**Community Environmental Response  
Facilitation Act (CERFA) Report  
Fort Wingate Depot Activity  
Gallup, New Mexico**

**U.S. Army Environmental Center  
Response to Regulatory Comments  
Fort Wingate Depot Activity Draft CERFA Report**

**U.S. Army Environmental Center  
Response to Internal Army Comments (Requested by the State of New Mexico Environment Department)  
Fort Wingate Army Depot Activity Draft CERFA Report**

DATE	12.13.93/04.09.94	CLIENT APPROVAL		
W.O. No.	PM307.70.01/1402-1	ISSUED FOR	DATE	SHEET 2 OF 4

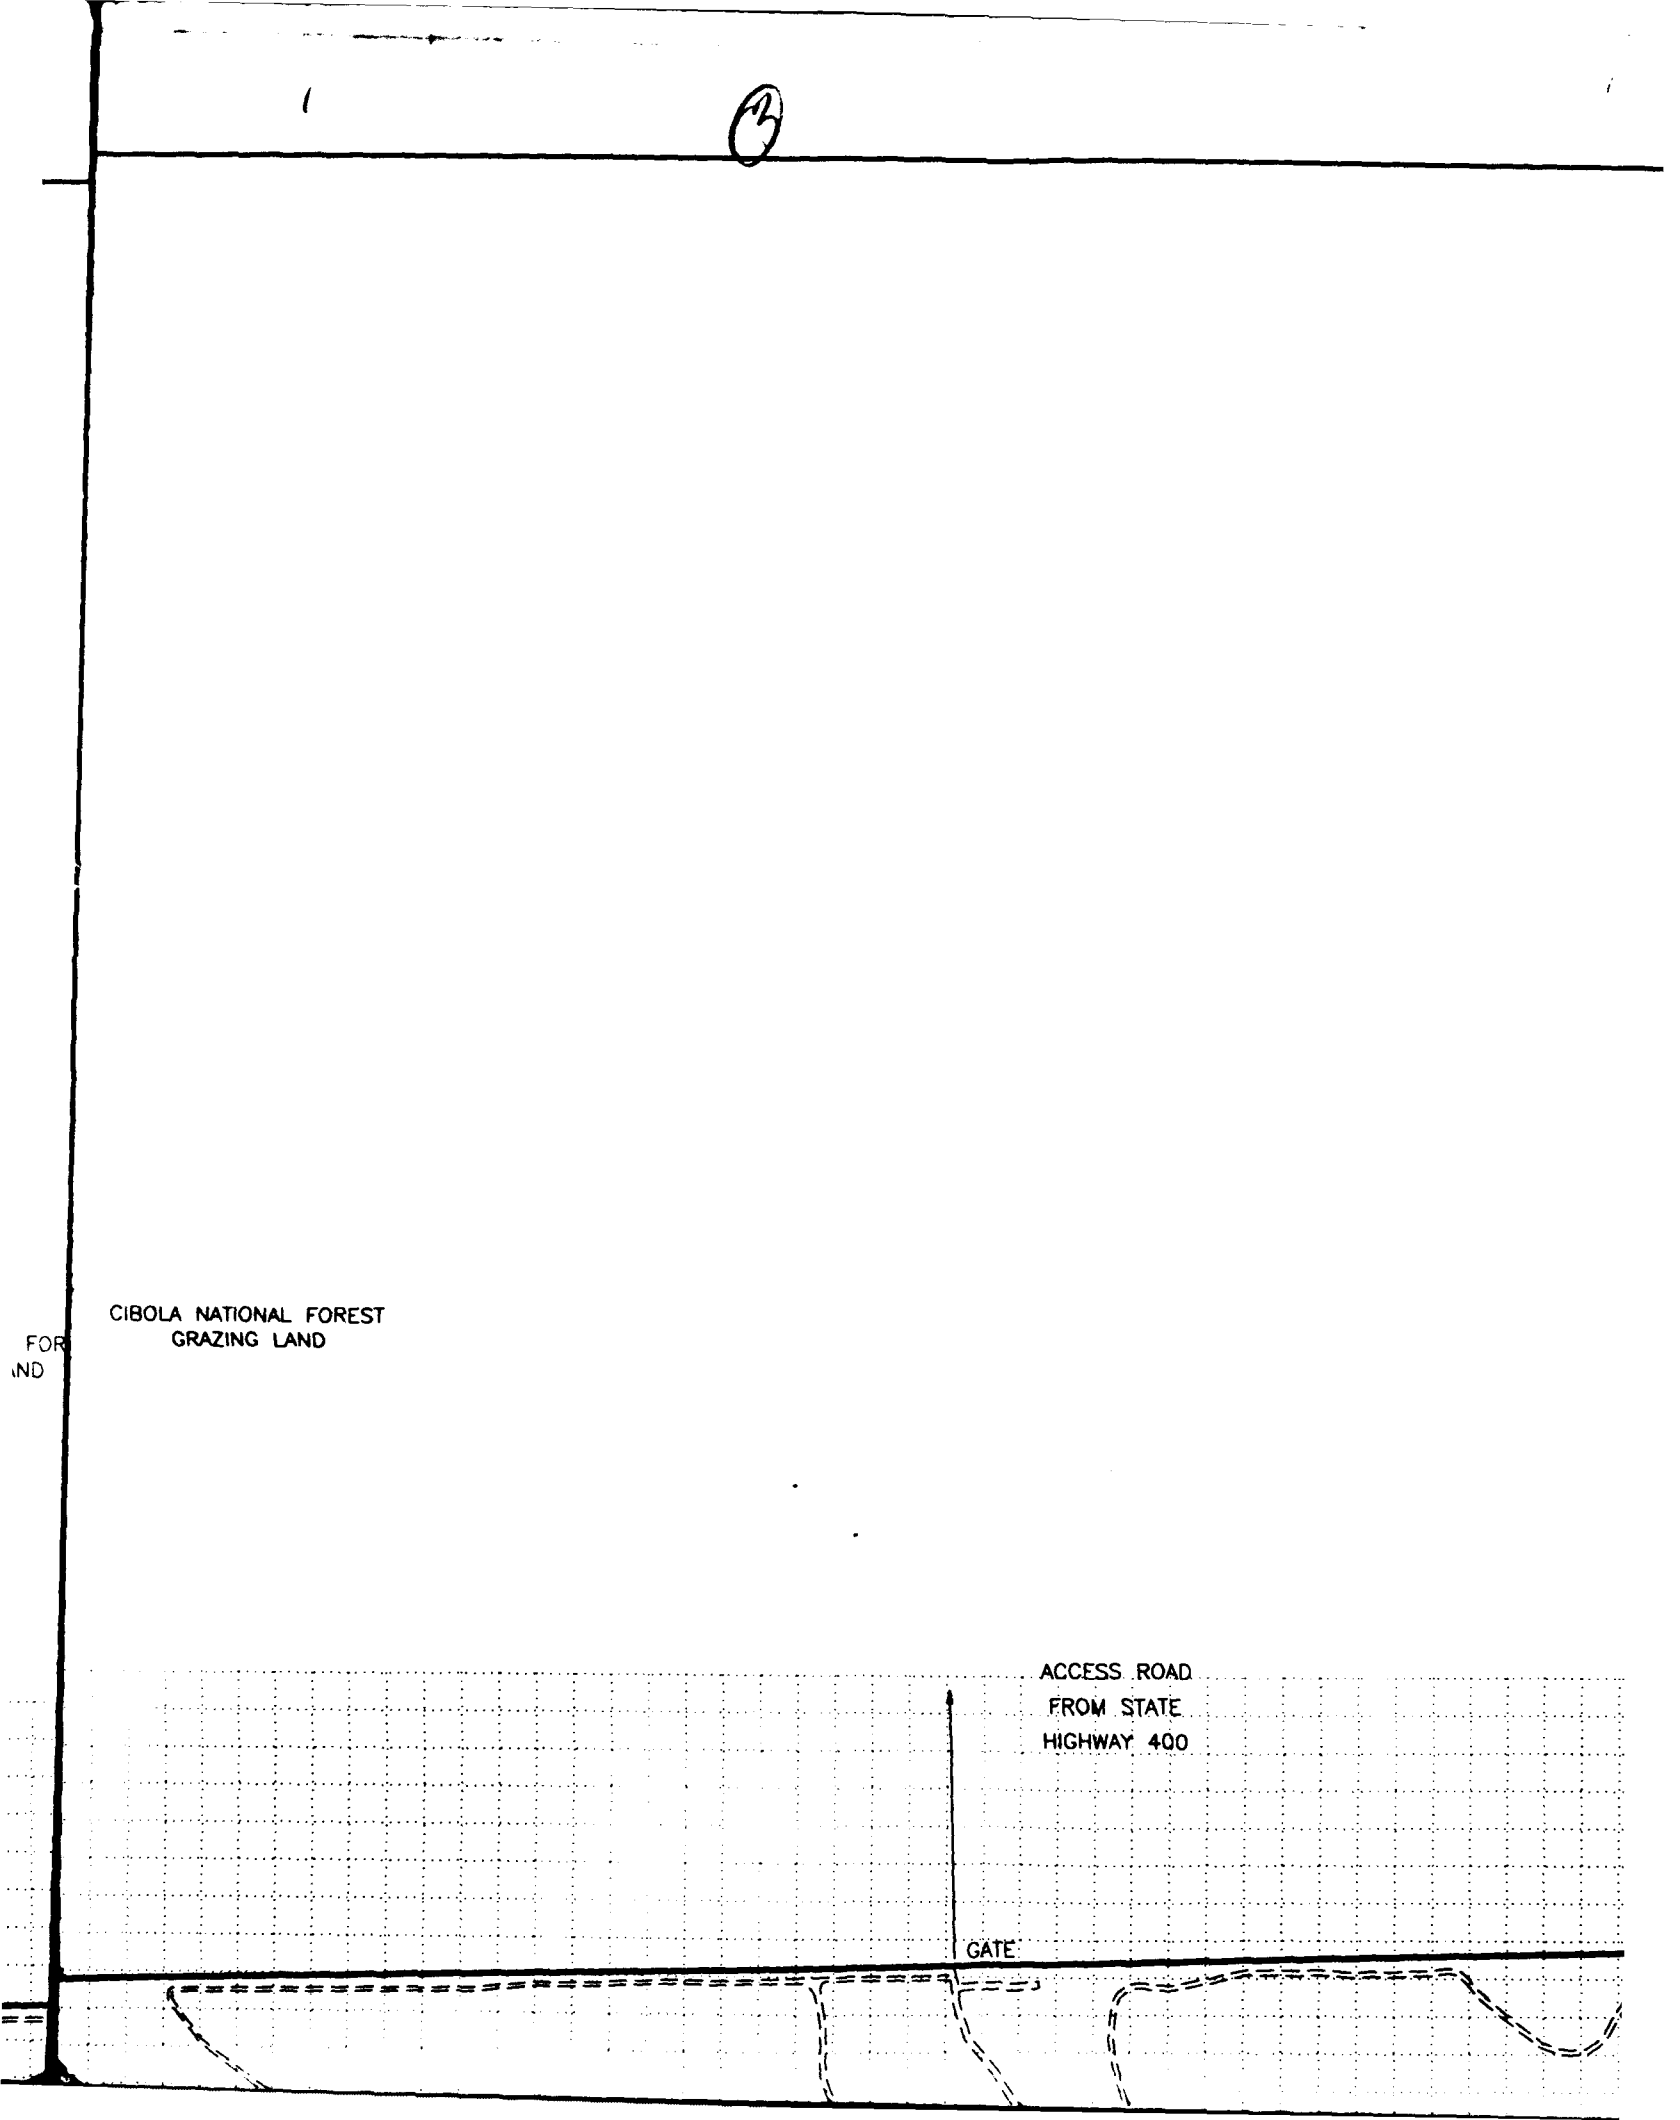
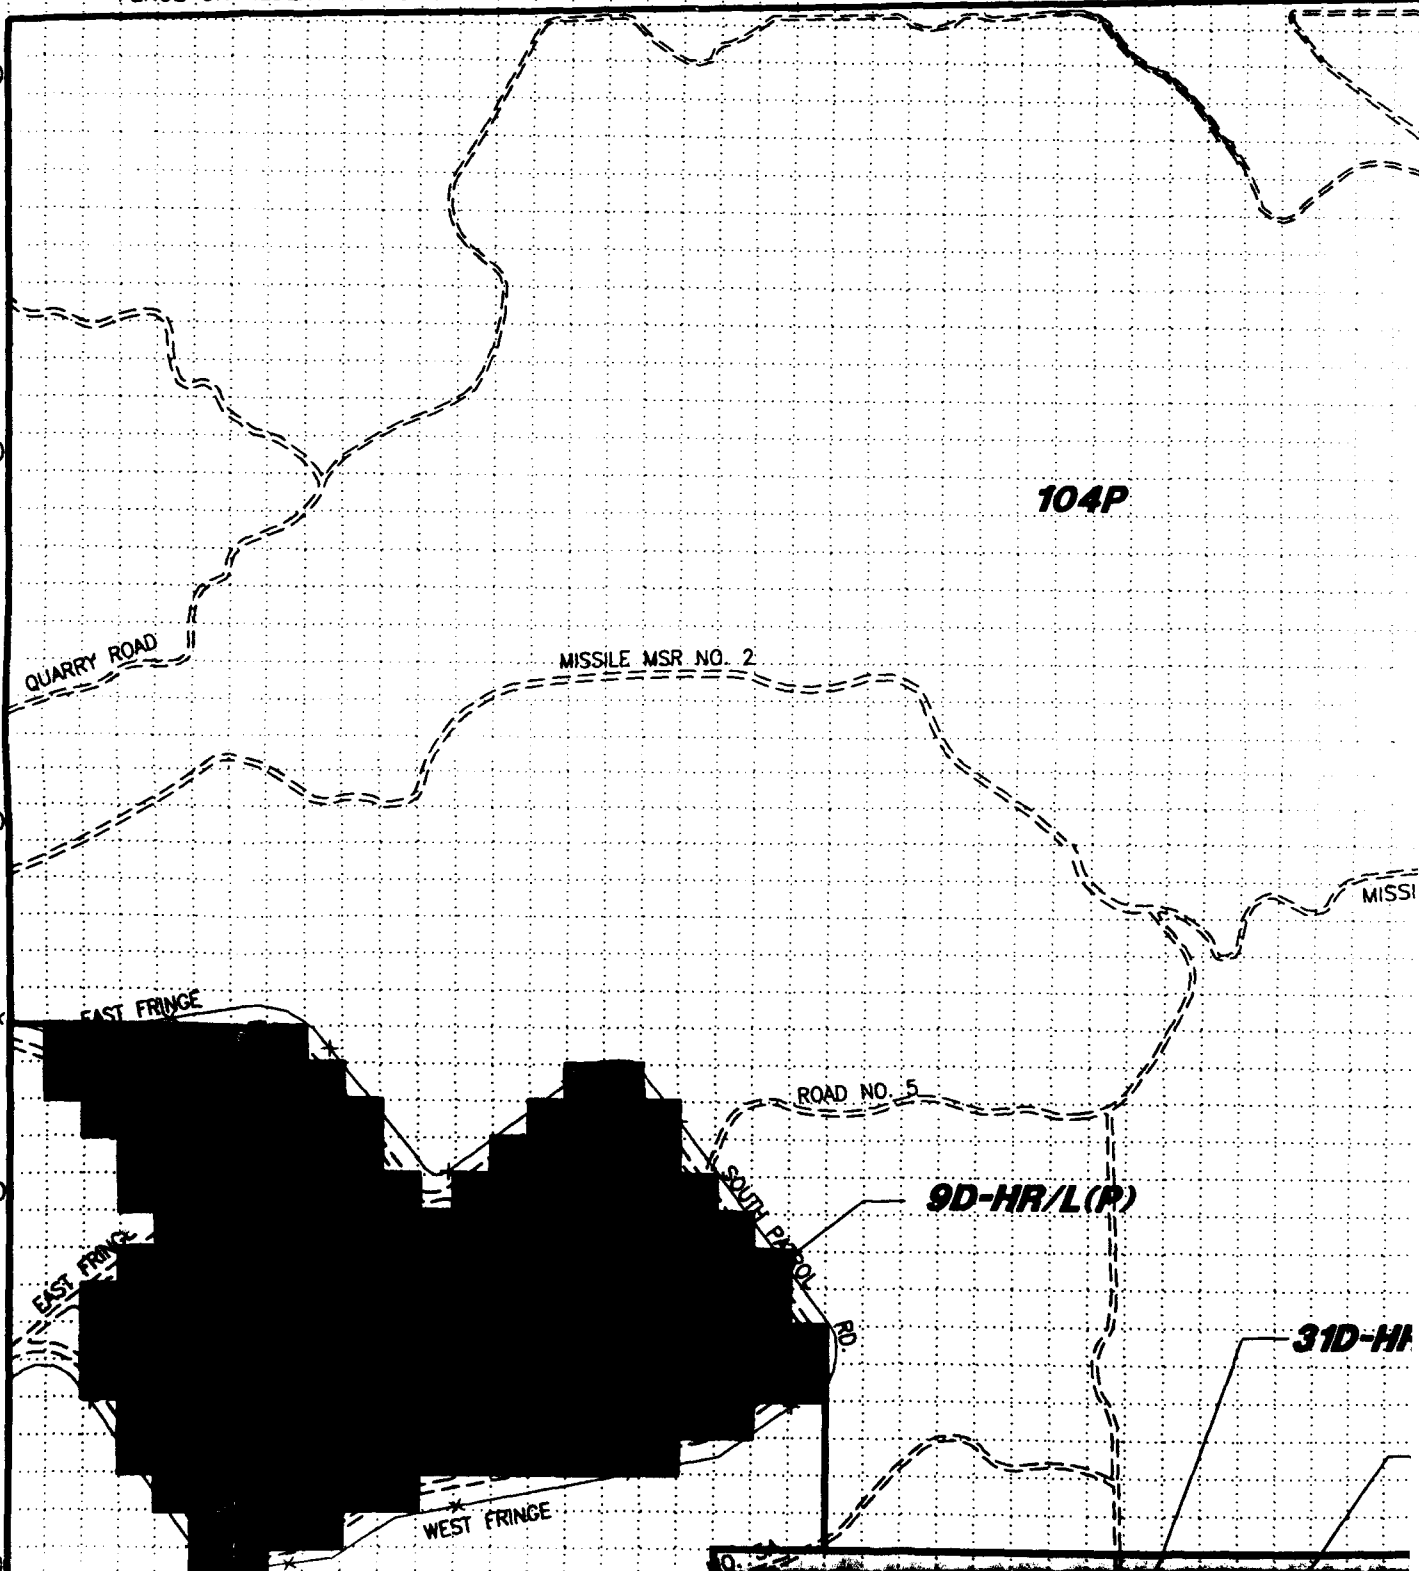
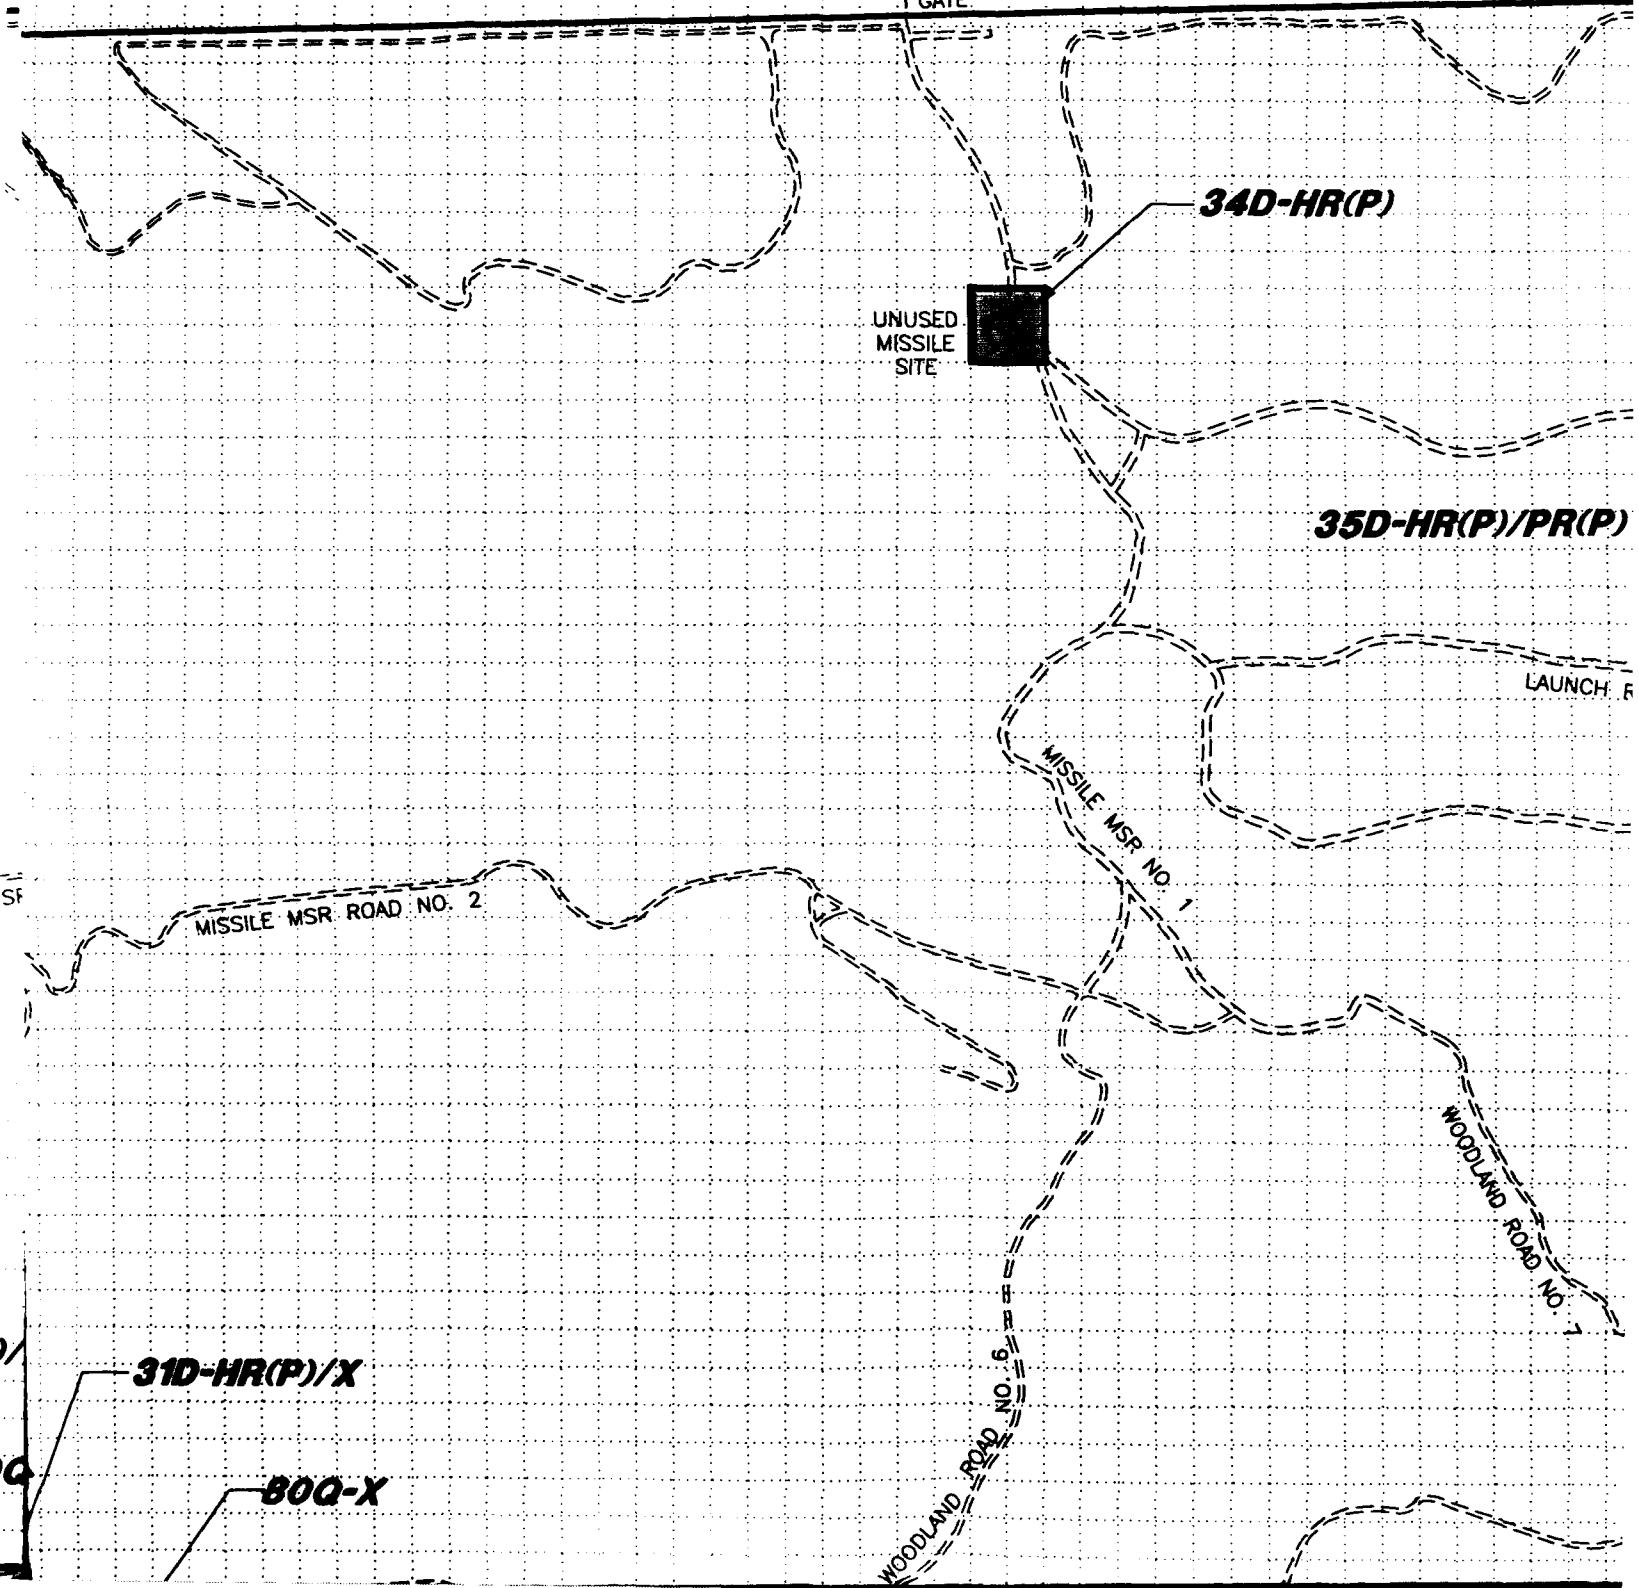
- This Center takes exception to your designation of the former ballistic launch sites. These areas were evaluated in the RI/FS and found not to be areas of environmental concern. You disqualify them due to potential hazardous and petroleum releases (Sheet 2 of 4). This is not accurate.

- This Center takes exception to your designation of the Old OB/OD areas (Sheet 2 of 4). What is the basis for the "HR" designation of these areas?
